HISTORIC AND DESIGN REVIEW COMMISSION

HDRC CASE NO: 2019-529
ADDRESS: 504 KING WILLIAM
LEGAL DESCRIPTION: NCB 749 BLK 8 LOT 9,10, NW IRR 28.2FT OF 1 & NW 61.2 FT OF 2
ZONING: RM-4,H
CITY COUNCIL DIST.: 1
DISTRICT: King William Historic District
LANDMARK: Steves, Albert - House
APPLICANT: Daniel Cruz/Design Coop
OWNER: Topher Guerra /LAUREL HEIGHTS FAMILY IRREVOCABLE TRUST
TYPE OF WORK: Construction of a second story porch
APPLICATION RECEIVED: August 30, 2019
60-DAY REVIEW: October 29, 2019
CASE MANAGER: Stephanie Phillips
REQUEST:

The applicant is requesting a Certificate of Appropriateness for approval to add a second level porch with turned wood balustrades and handrail. The proposed turned balustrades are to generally match the design and proportions of the 1915 configuration, are proposed to be 36" tall to comply with residential code.

Albert Steves Home ≈ 504 King William as it appeared in 1915 after a major renovation.

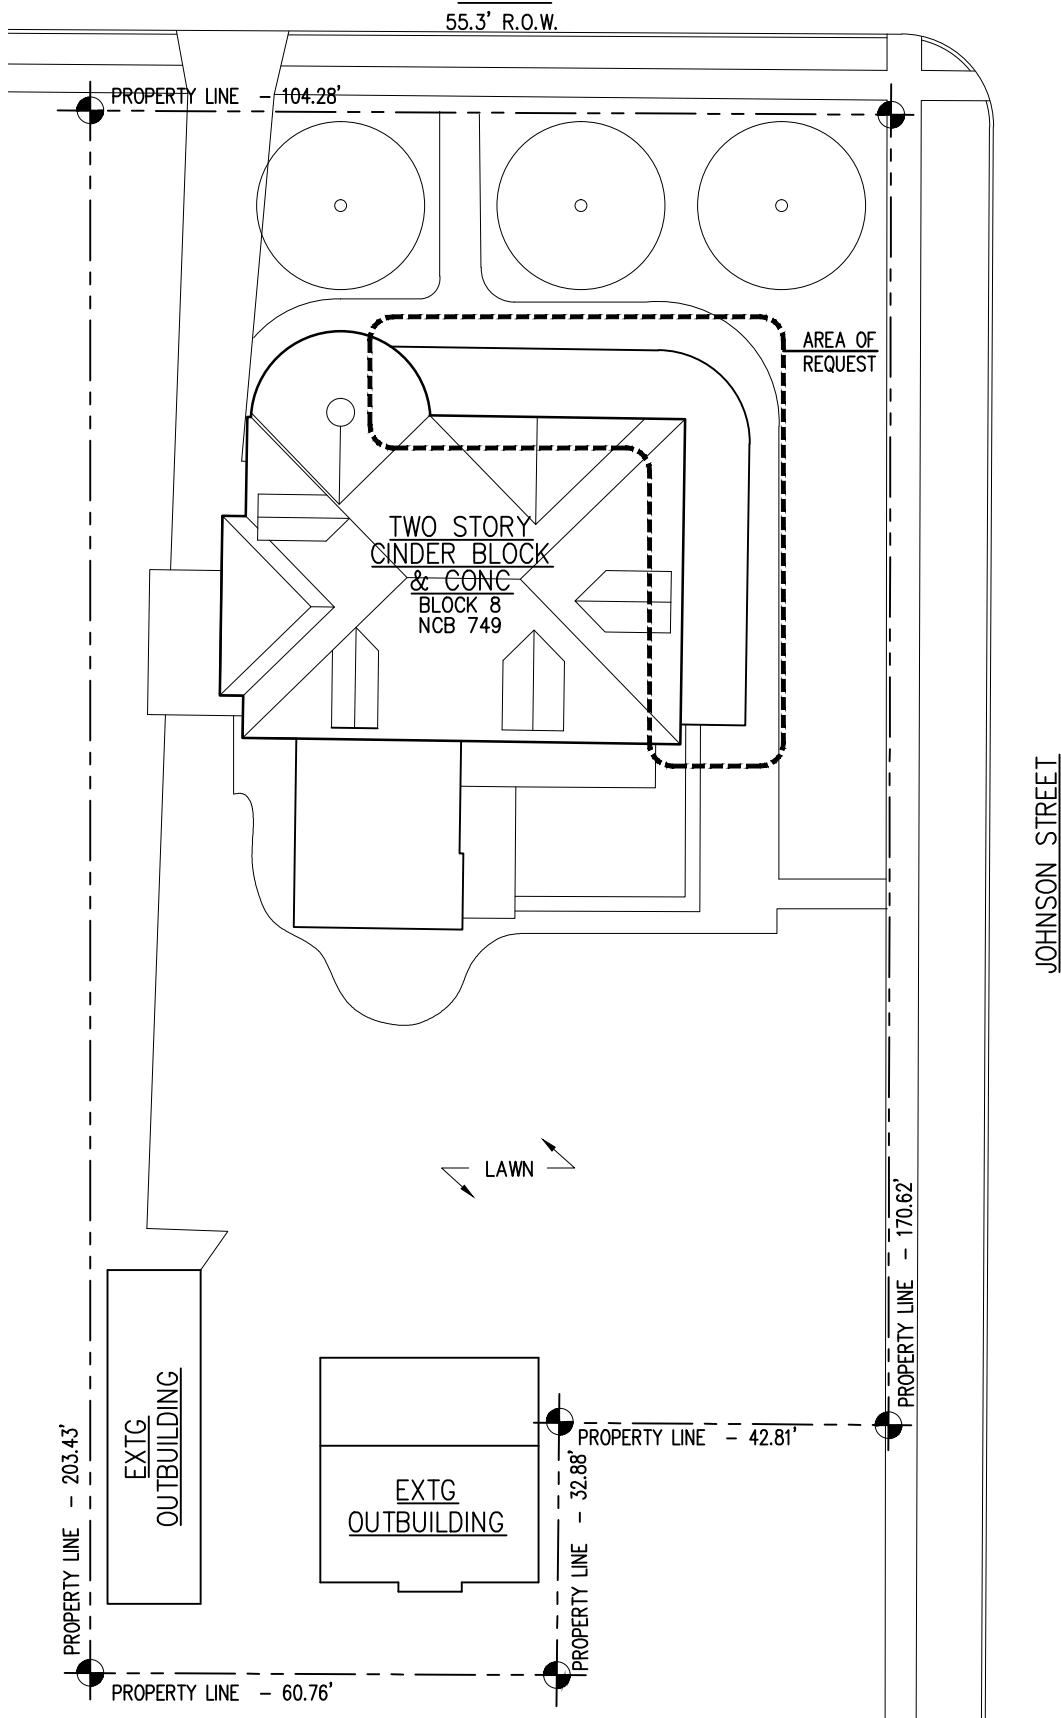
- c. LOCATION – The applicant has proposed to construct a second story wraparound porch. The porch will extend from the central front façade towards the rear of the structure, on the northern side elevation. The existing case stone decorative frieze above the front door will remain. Based on historic photographs of the structure, a wraparound porch existed previously in this location. Based on this evidence, staff finds the general location consistent with the Guidelines.

DTL SECTION: HANDRAIL
 SCALE: 1 1/2" = 1'-0"

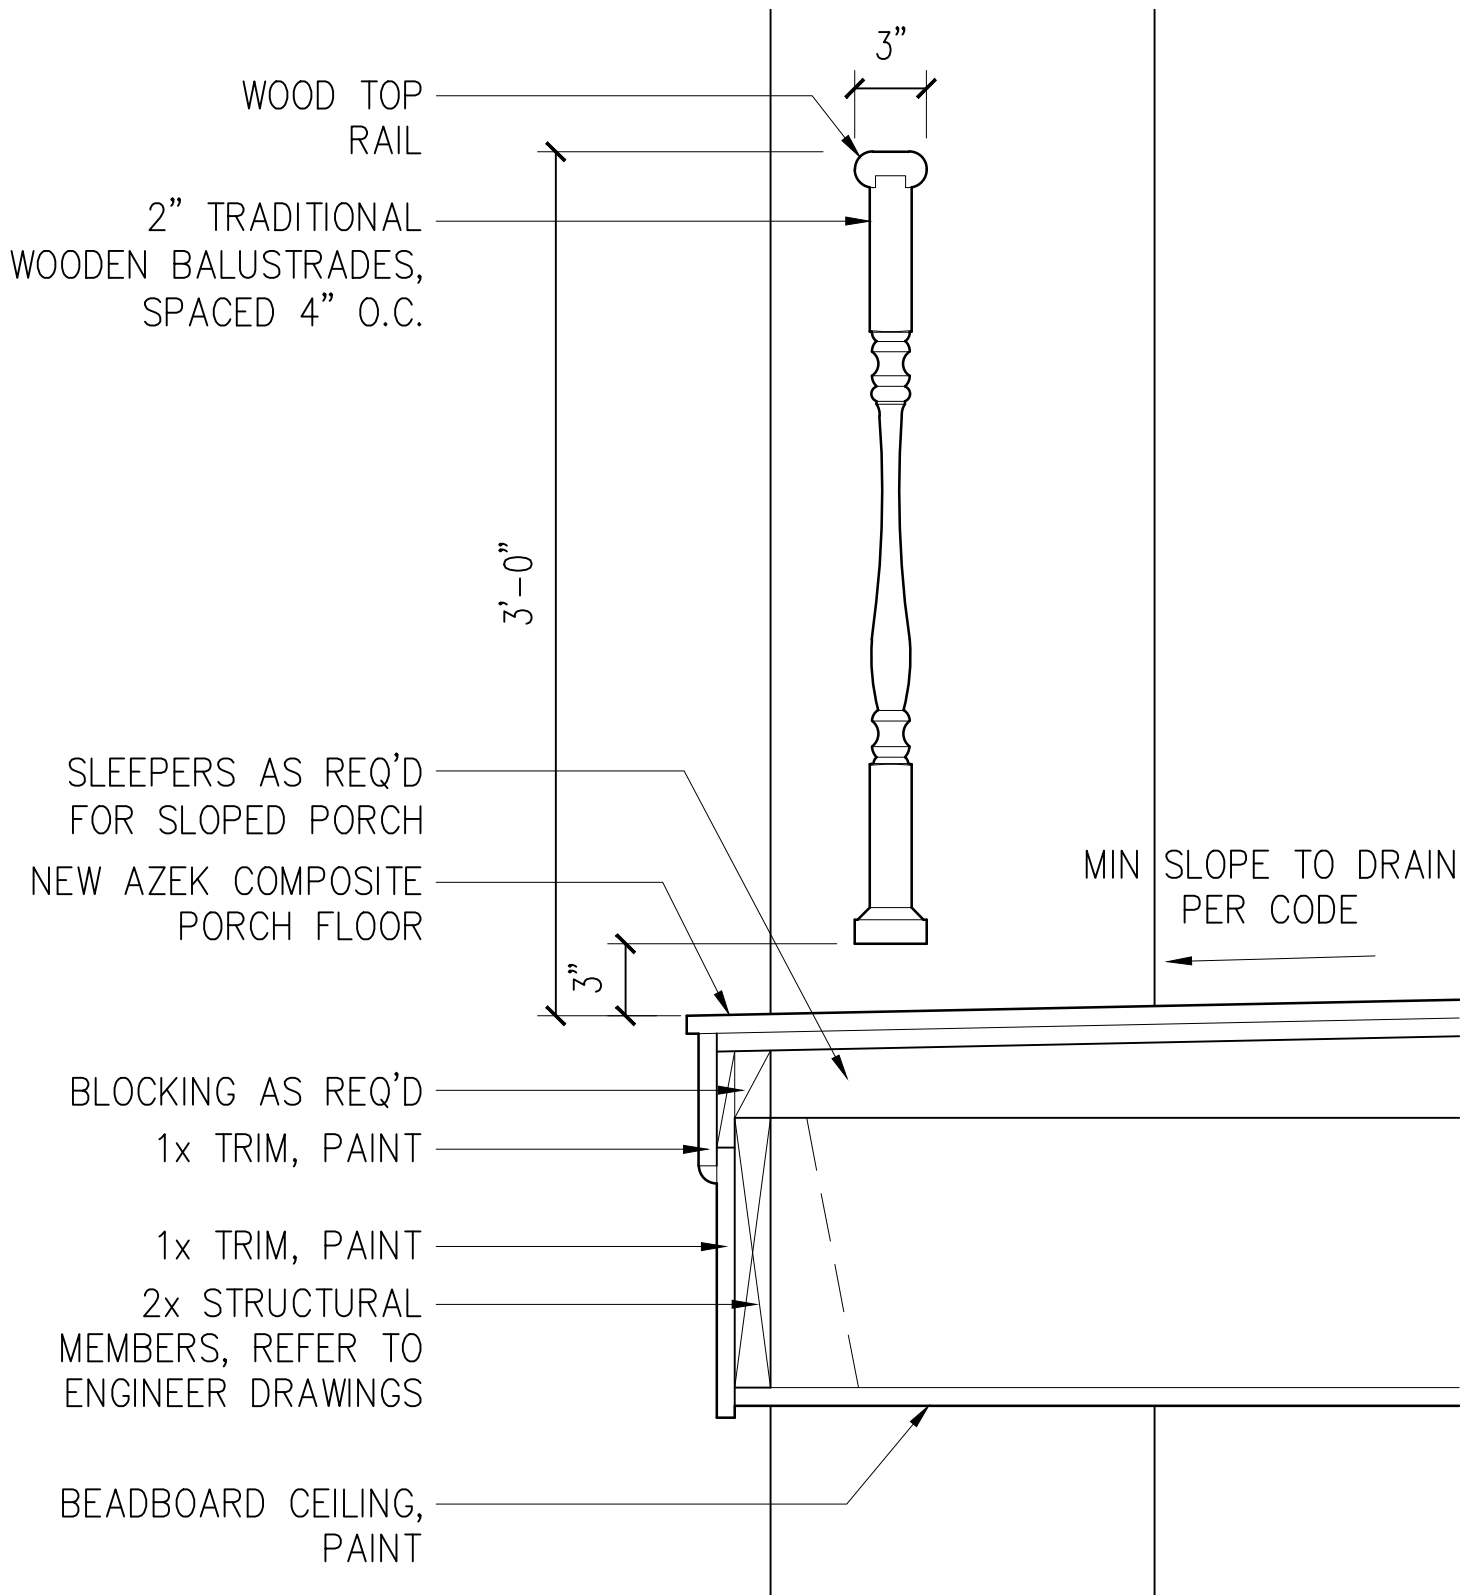
- d. DESIGN – The applicant has proposed a wooden guardrail and composite decking for the porch floor. The supportive floor substrate is not indicated on the submitted plans. The guardrail will be a simple wooden post design with a rail at the historic height (approximately 2’-6”) and a smaller baluster and rail atop for a total height of 3’-6”. The bottom balusters will measure 1.25” square with a spacing of 4” and the top balusters will measure 1” square with a spacing of 4”. According to the Historic Design Guidelines, porches should be reconstructed based on accurate evidence of the original, such as photographs. If no such evidence exists, the design should be based on the architectural style of the building and historic patterns. Staff finds that the design as proposed is not consistent due to the photographic evidence of the previous porch. Staff finds that the applicant should restore the porch to its 1915 configuration, including the inclusion of wooden turned balustrades at their original height. The applicant may install a second guardrail structure, secondary in design and location, to achieve minimum code requirements.

- i. That the height of the proposed wood turned balustrades match the height of the 1915 porch configuration as evidenced by archival photographs. The applicant may propose a secondary, subordinate design detail to meet existing code railing height requirements or the proposed 36” height as noted in finding d. Updated drawings are required to be submitted to staff for review and approval prior to receiving a Certificate of Appropriateness.
